FLOOR PLAN — REV K

REV K · 22 SEP 2026 8:18 AM · TO SCALE
ANCHORED ON THE 12×24 GARAGE

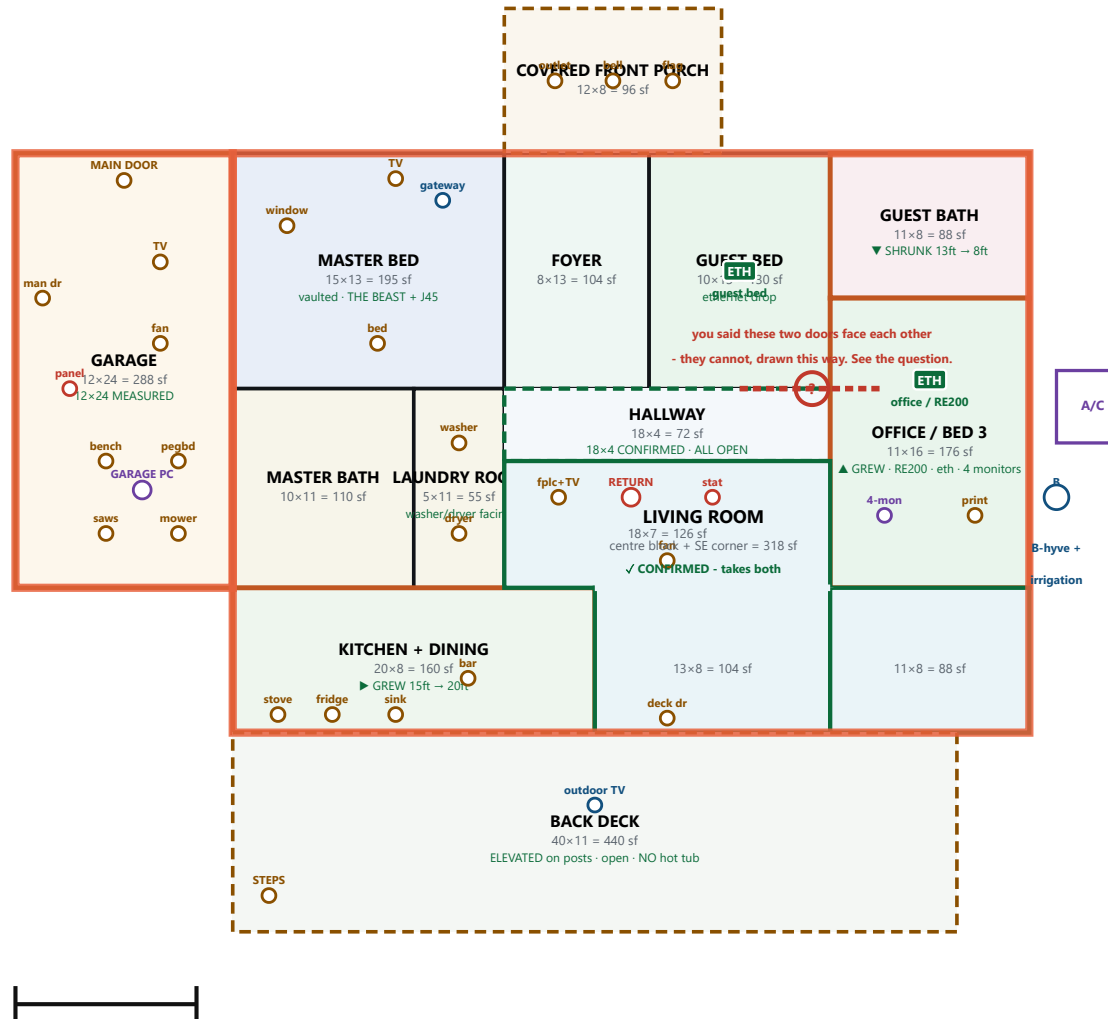
Living room confirmed as one L (centre + SE corner). Hallway confirmed 18×4 and redrawn OPEN. Guest bath shrunk, kitchen grown. One question left — the two doors you said face each other cannot, drawn this way.

- ✓ “the living room takes both the center block and the south east corner” — already drawn that way and now locked. It is one L-shaped room, 318 sf, wrapping the kitchen. That was the biggest open question and it is closed.
- ✓ “the hallway is right at 18 x 4 but it’s all open” — the numbers were right, the walls were not. It is now drawn dashed: a named circulation space, not a corridor.
- ▼ “the guest bathroom can be shrunk down a little” — cut from 11×13 to 11×8 (143 → 88 sf). The 55 sf went next door to the office.
- “the kitchen, of course is much bigger” — grown east, 15×8 to 20×8 (120 → 160 sf).

You said the guest bedroom and office doors are straight across from each other. On this plan they cannot be: the guest bed is on the north side of the hallway and the office is off its east end. Those two doors are around a corner from each other, not facing.

For them to face, the hallway's **18 ft has to run north-south, not east-west** — a **4 ft wide by 18 ft long** spine with the guest bed on one side and the office on the other. Same two numbers, turned 90°.

Which is it? If it is the north-south spine, say so and I will re-cut the whole east half around it — that also changes where the guest bath and the ethernet drops land. **I am not going to redraw the house off my own inference.**

Why the kitchen grew east and not south: the envelope is still **44 × 32** and the total is still **1,408 sf** against your recorded 1,400 — so the kitchen had to take its extra 40 sf from somewhere inside, and the only side it touches is the living room. **If the kitchen is bigger than that, the outside wall has to move** and the 1,408 goes with it. Tell me and I will move it.
